URBAN DESIGN COMMITTEE

URBAN DESIGN COMMITTEE STAFF REPORT

APPLICATION NUMBER	Urban Design Record #23110
APPLICATION TYPE	Advisory Review
ADDRESS/LOCATION	139 S 10th Street
HEARING DATE	September 05, 2023
ADDITIONAL MEETINGS	-
APPLICANT	Derek Zimmerman and Justin Hernandez, derek@revdev.com
STAFF CONTACT	Arvind Gopalakrishnan, 402-441-6361, agopalakrishnan@lincoln.ne.gov

ATTACHMENT C – Option 1 (with screening)

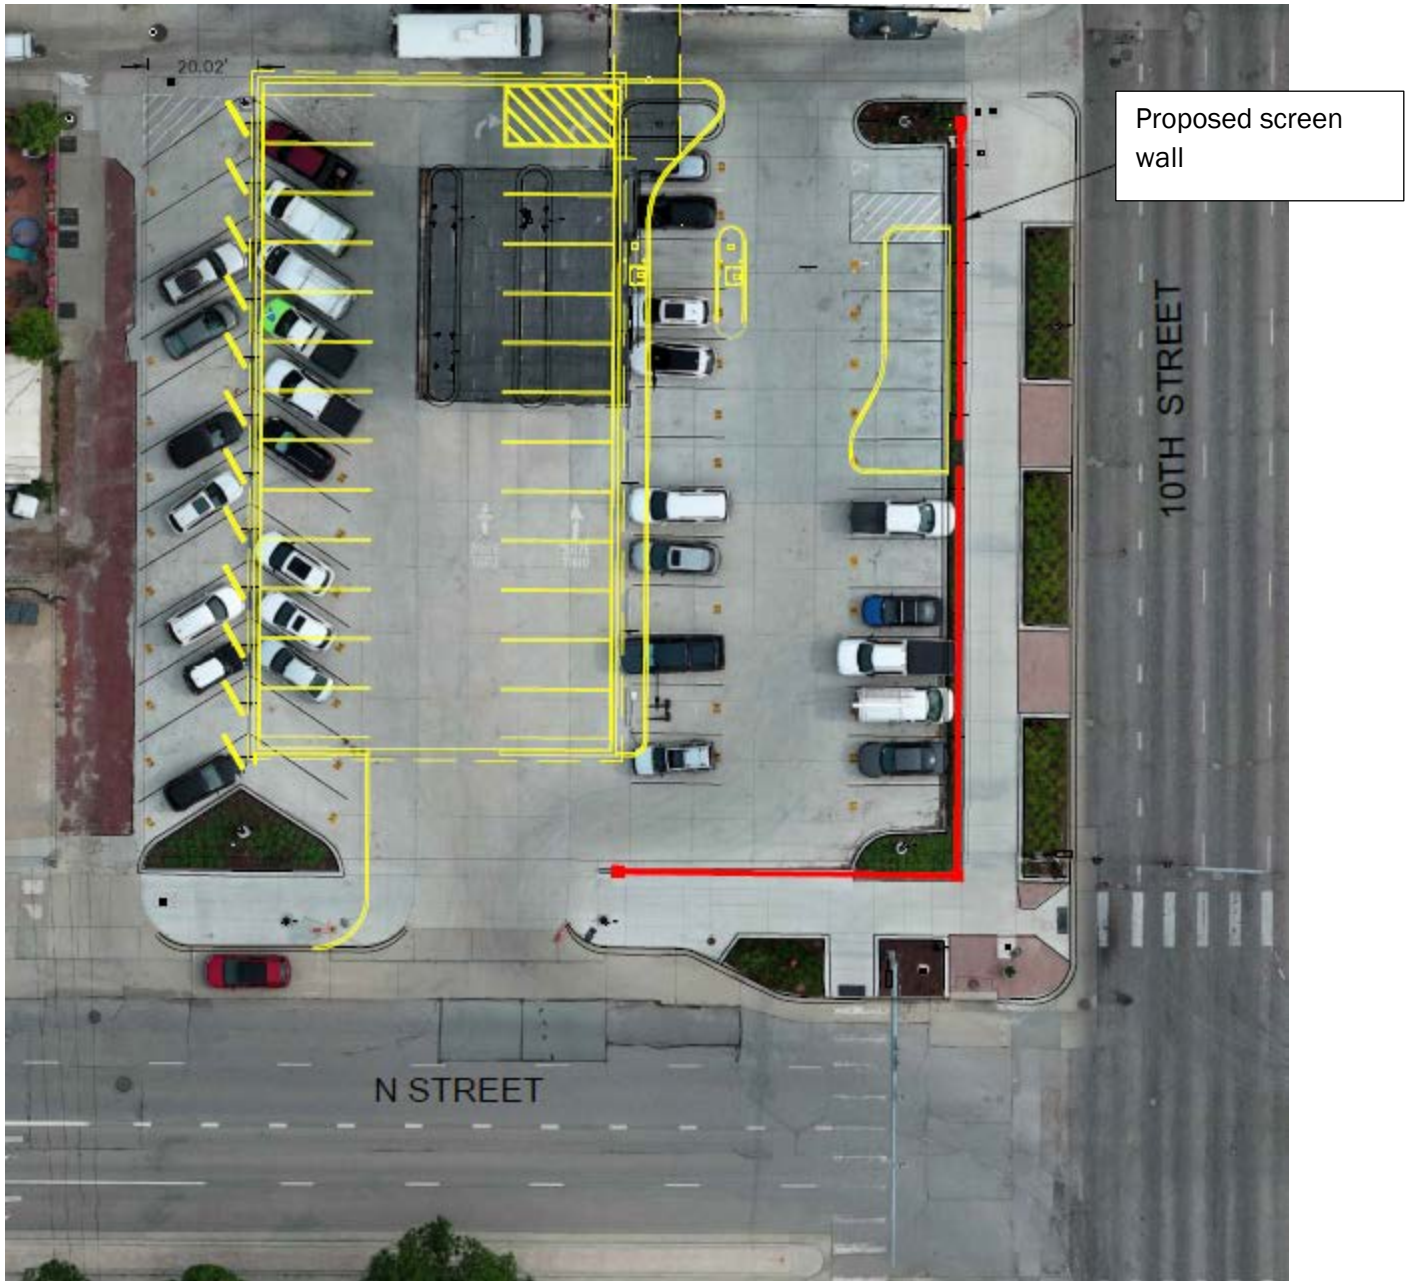
Screen Location, Coverage, and Layout (7.13 Screening for Downtown Lincoln) - *Further detail is needed to see if this proposal meets parking lot screening requirements. Option 1 shows a masonry wall along 10th street and part of N street*
